EAST WHITELAND TOWNSHIP – ACT 537 PLAN DOCUMENTS
(SPECIAL STUDY 2011)

“SPECIAL STUDY”

**Revised September 2011
AGC Project No.: 2009-2412**

RE: "Special Study" Act 537 Plan Amendment – Response to PADEP Comments
East Whiteland Township / Mill Lane Pumping Station Replacement Project

FIGURE 4B TABLE
REVISED MUNICIPAL CONNECTION POINTS
PROJECTED FLOWS

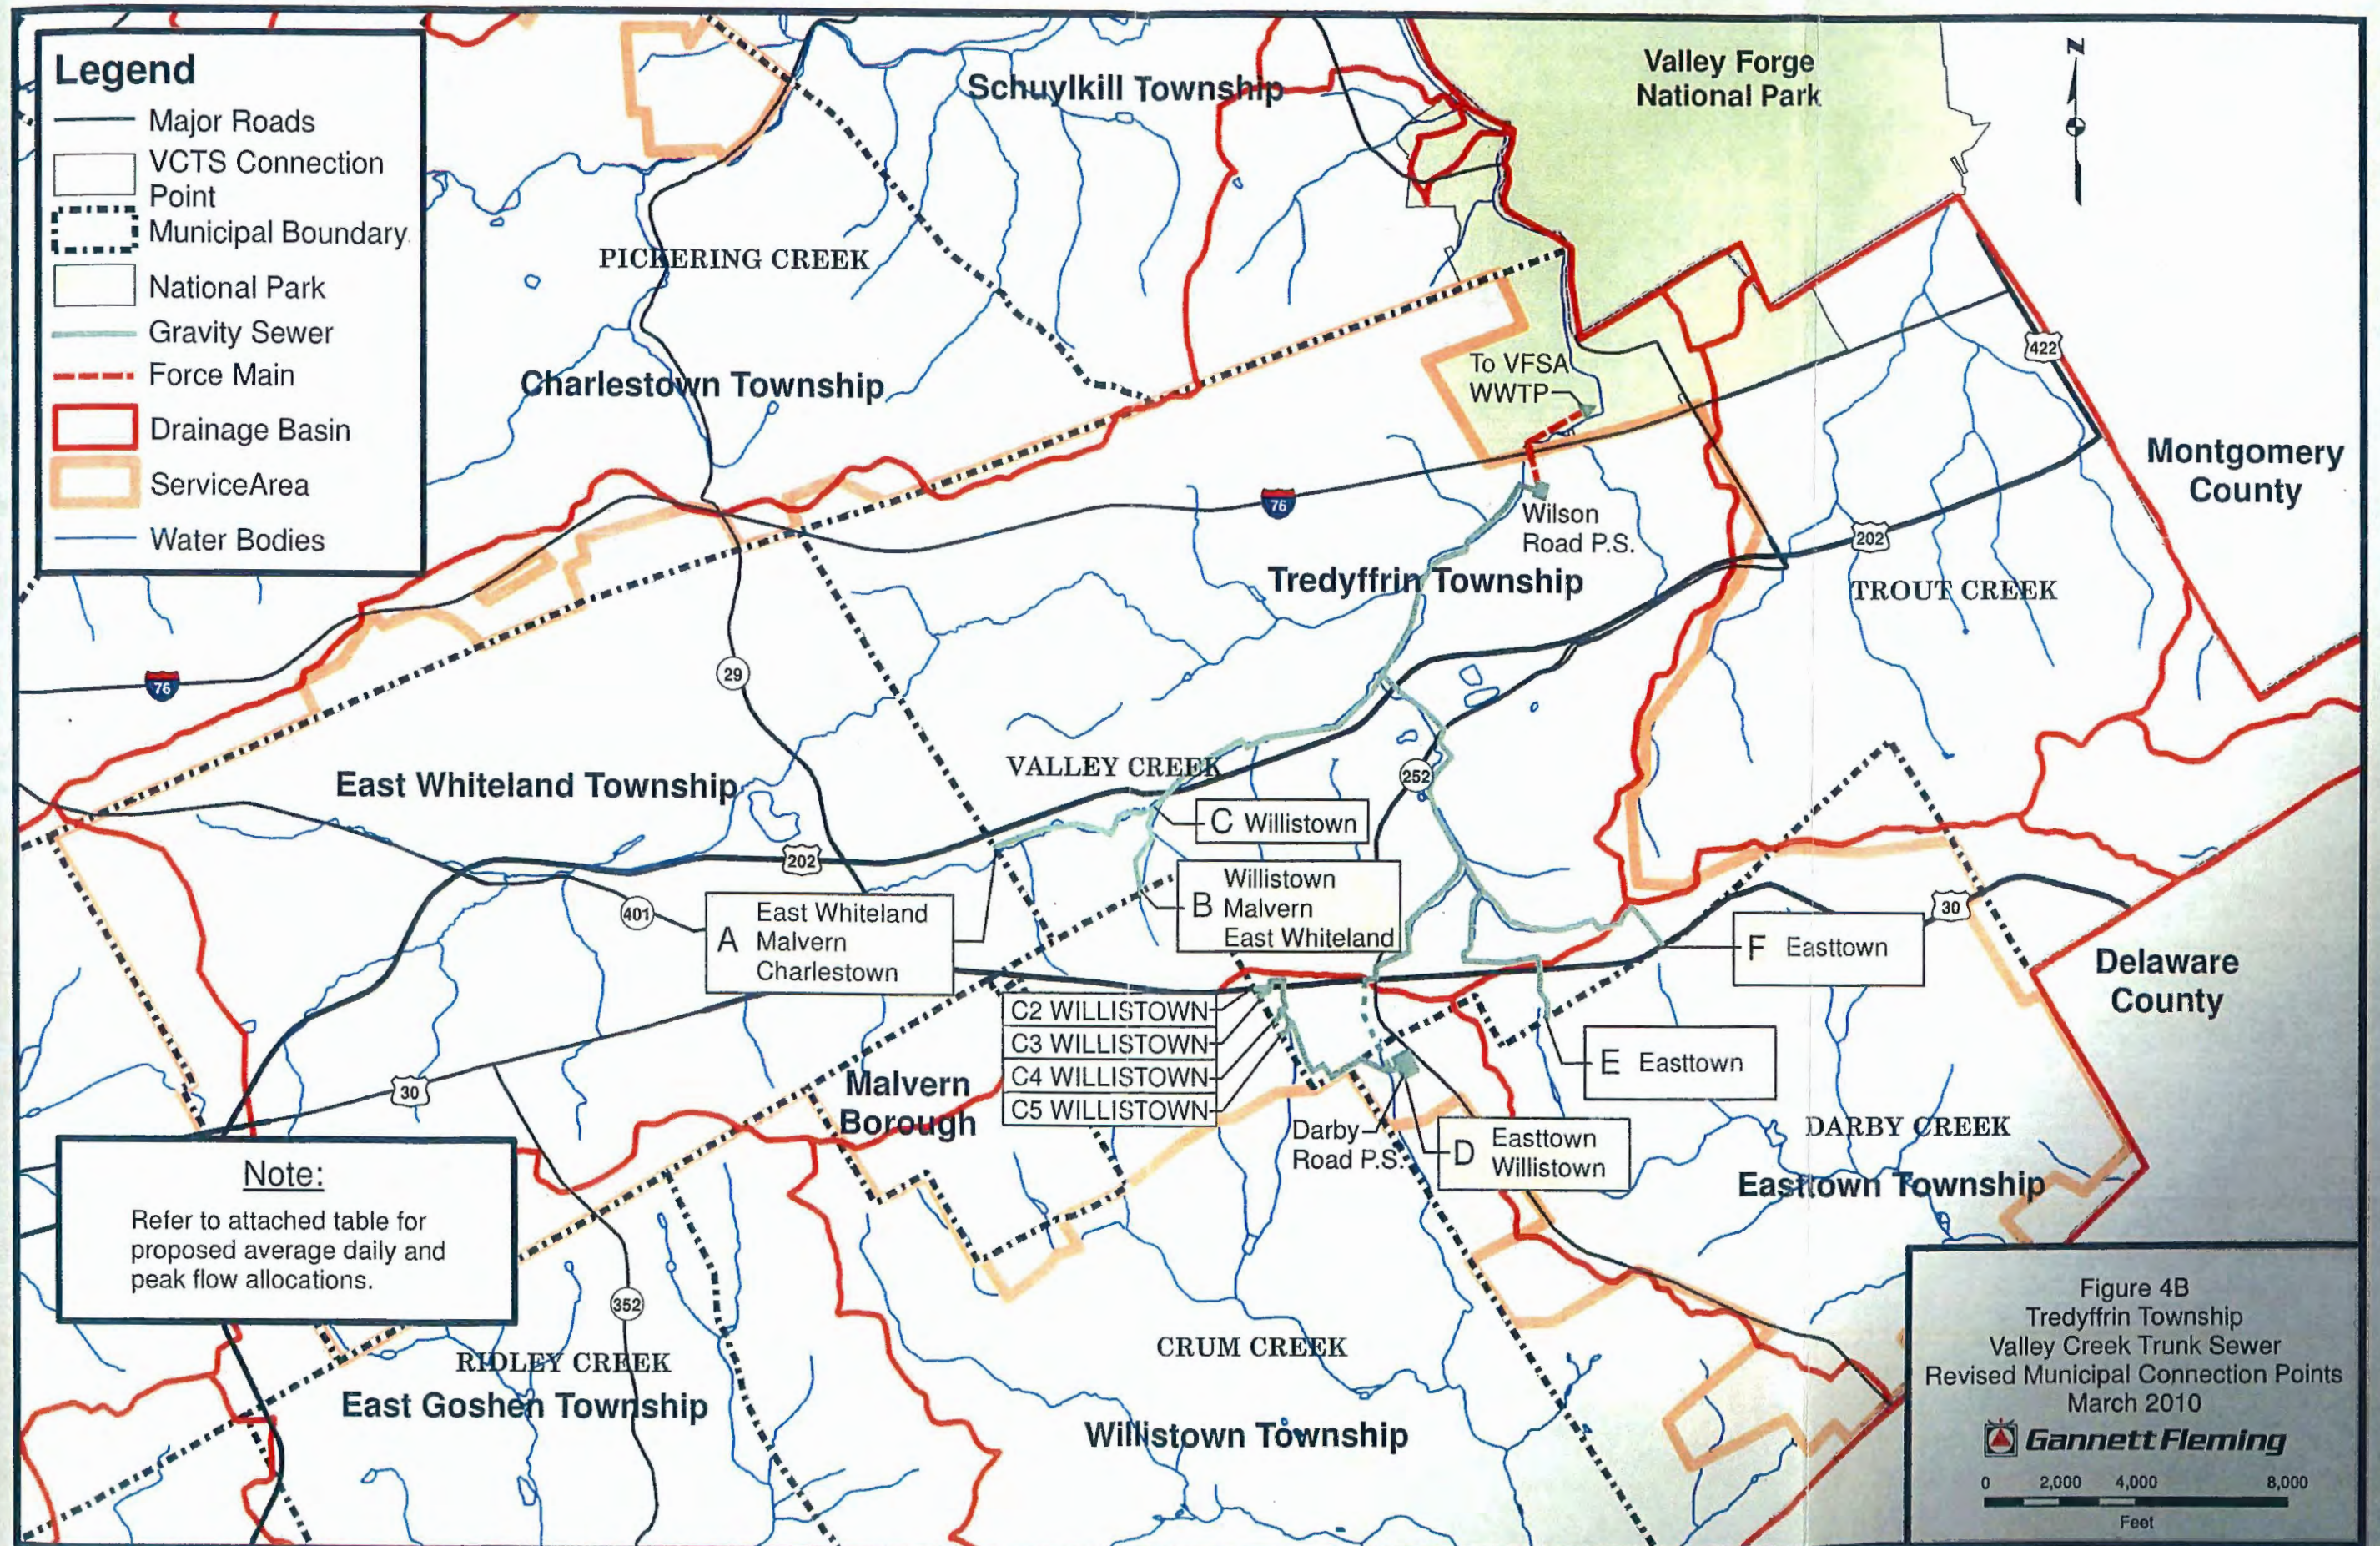
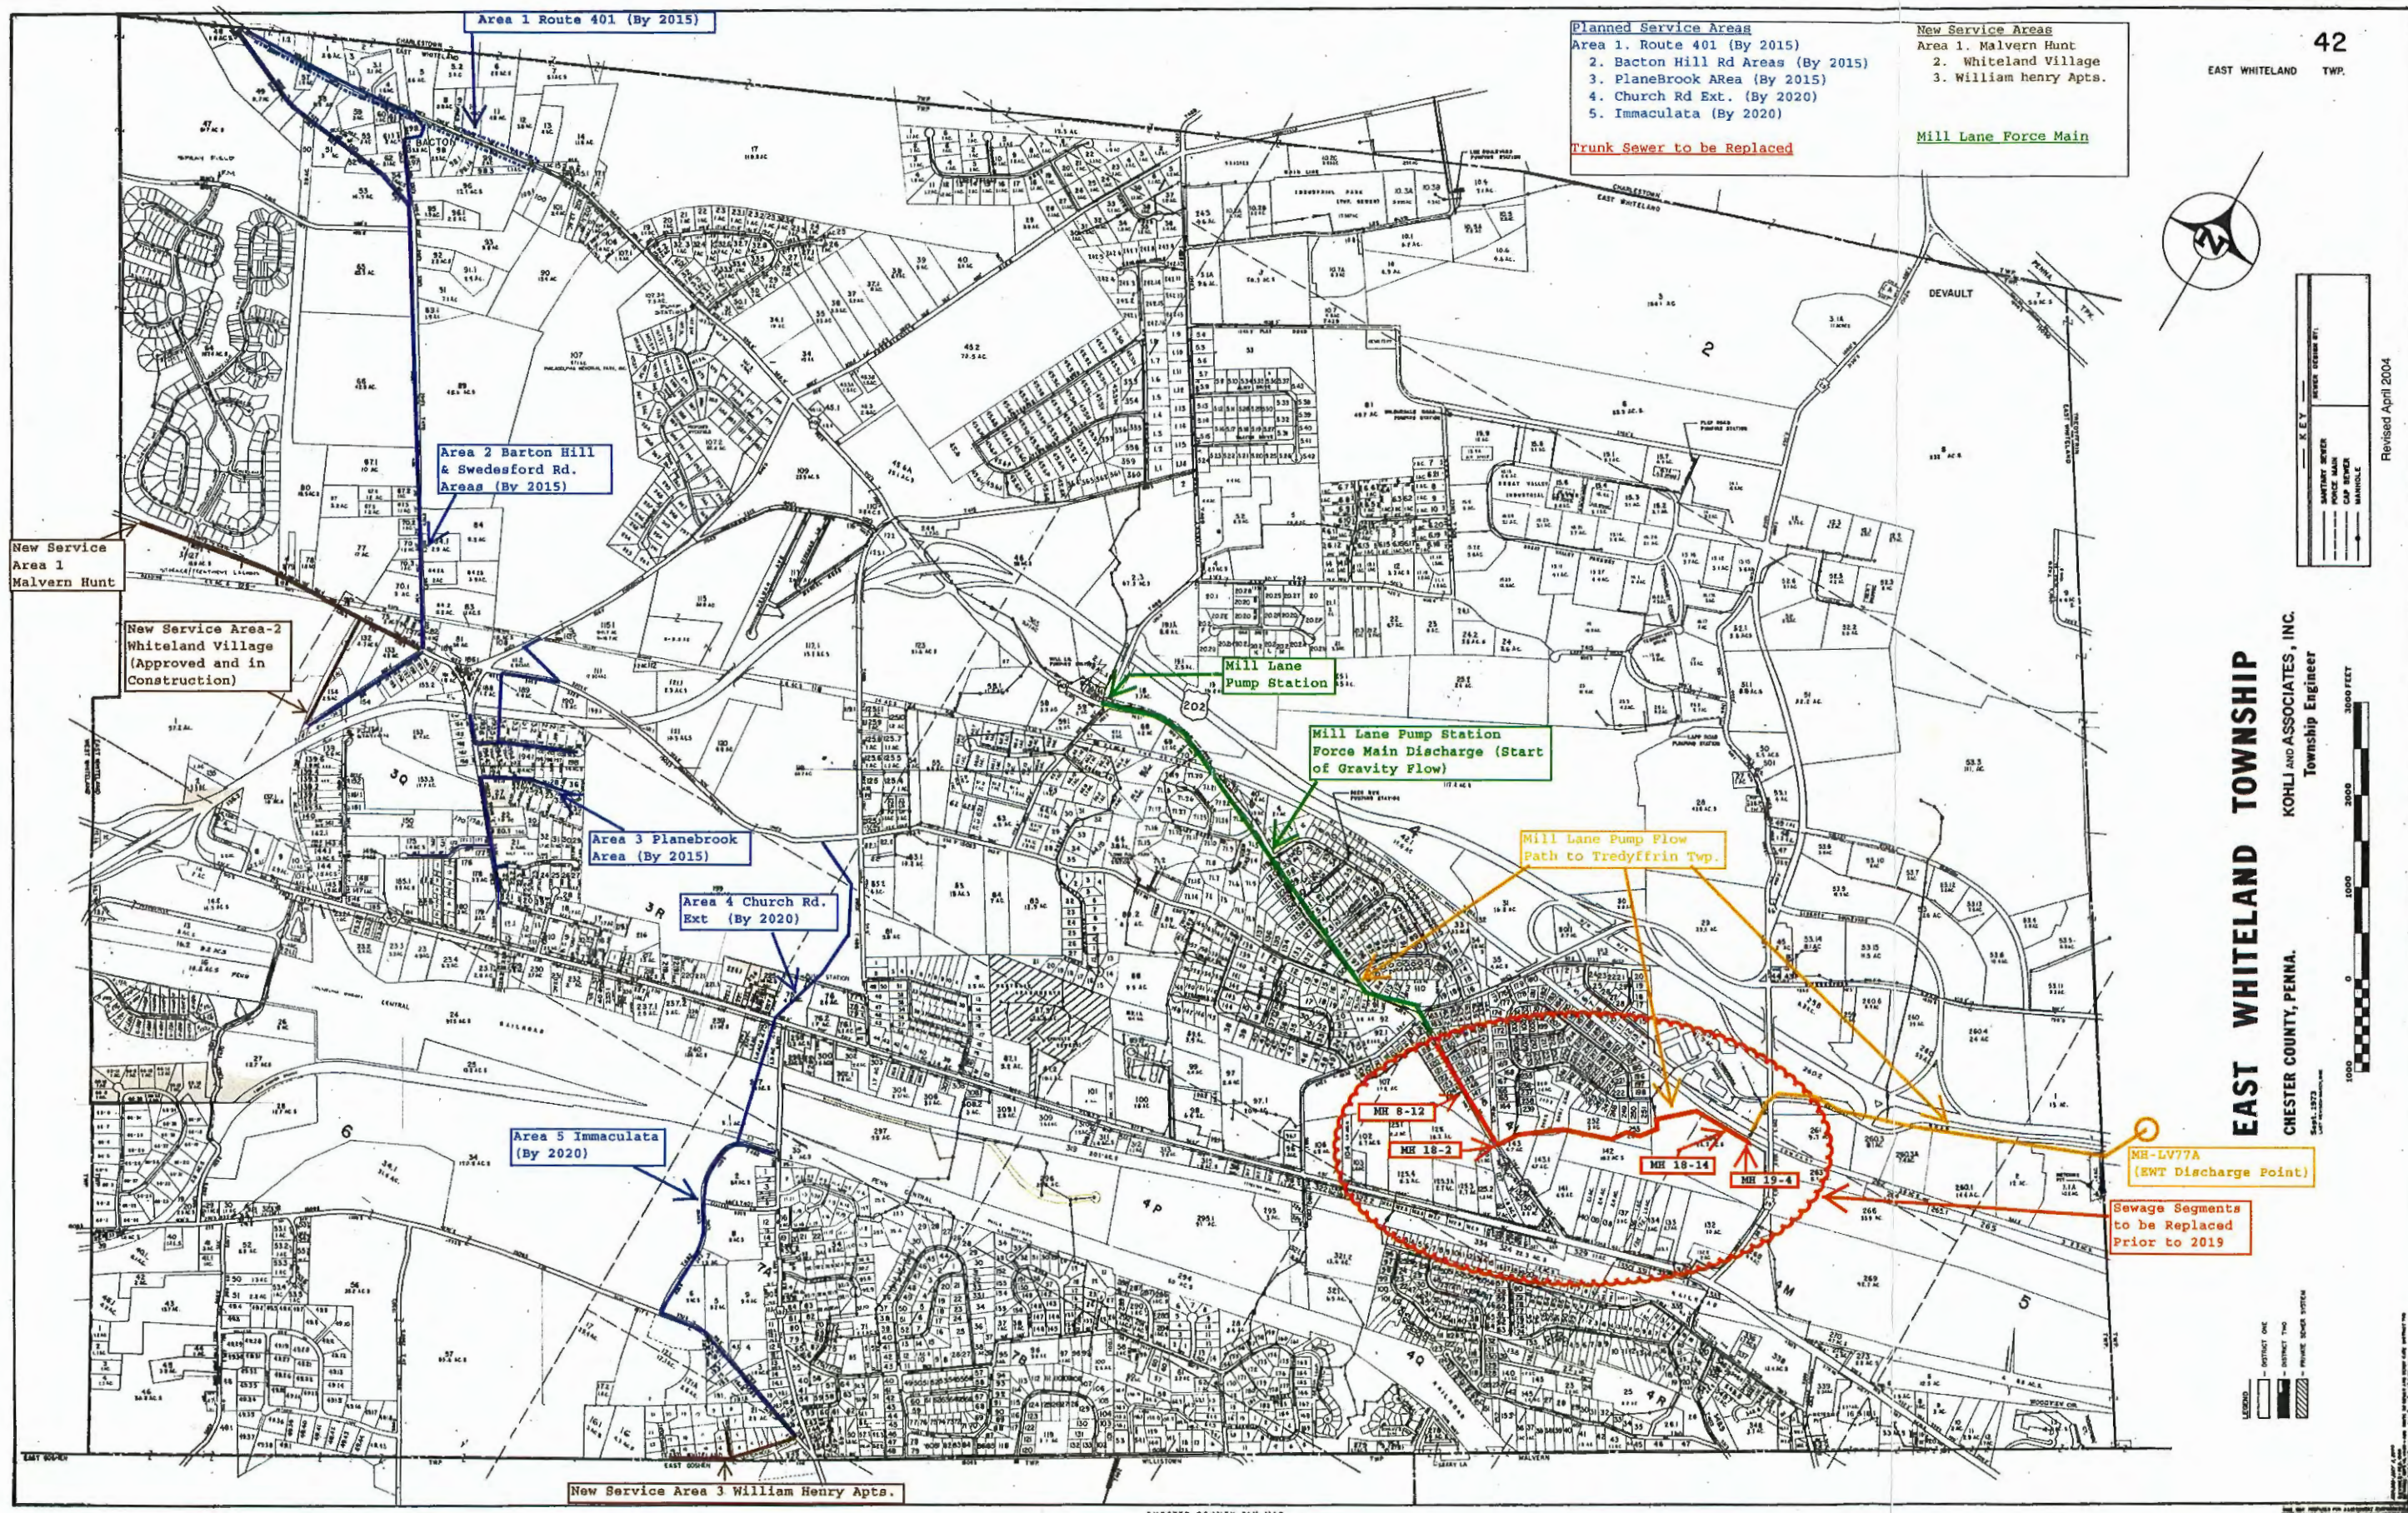
13. The submitted Special Study indicates that the 2035 projected flows for the Township are available in the flow already allocated to the Township from both Tredyffrin Township and the VFSA. Please provide correspondence from both Tredyffrin Township and VFSA confirming this statement.

Attached as Exhibit 3 is a table and figure from Tredyffrin's recent Act 537 Plan Revision for Valley Creek Trunk Sewer dated April of 2010. This correspondence documents the

projected flows for EWT as it pertains to Tredyffrin's the VCTS project improvements. These projected flows coincide with what has been summarized in EWT's Act 537 Plan "Special Study" report.

537 Data - 15.8 MGD, $n=0.013$
Full Pipe Condition

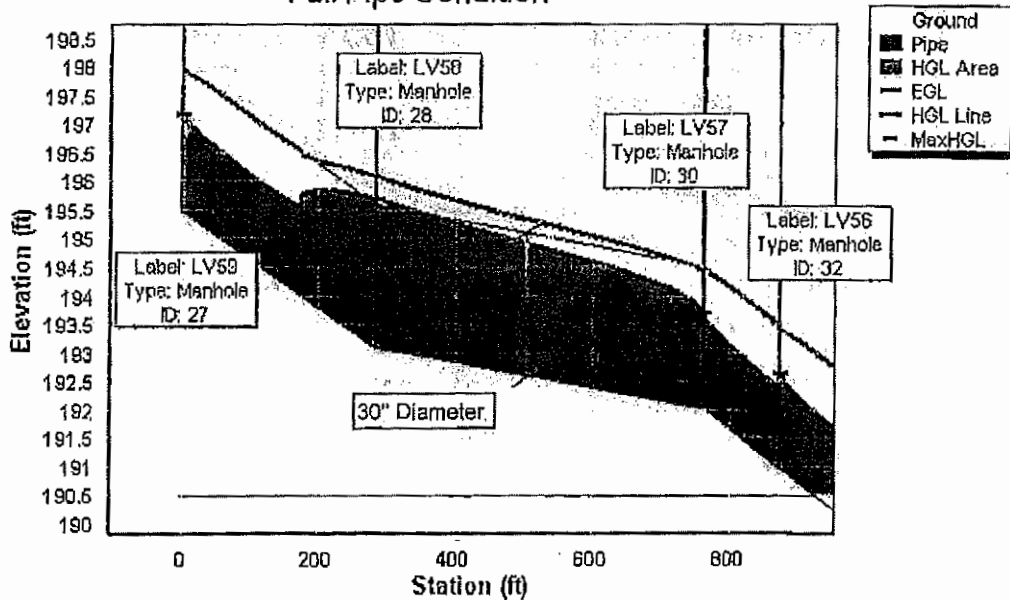
Note: LV58 Drawing invert of 193.10' was used for the model. All other inverts were adjusted based on slopes and lengths indicated in the October 2010 Act 537 Plan Revision. Ground elevation (top of manhole) at LV58 = 202.55' (therefore LV58 depth is 9.45').
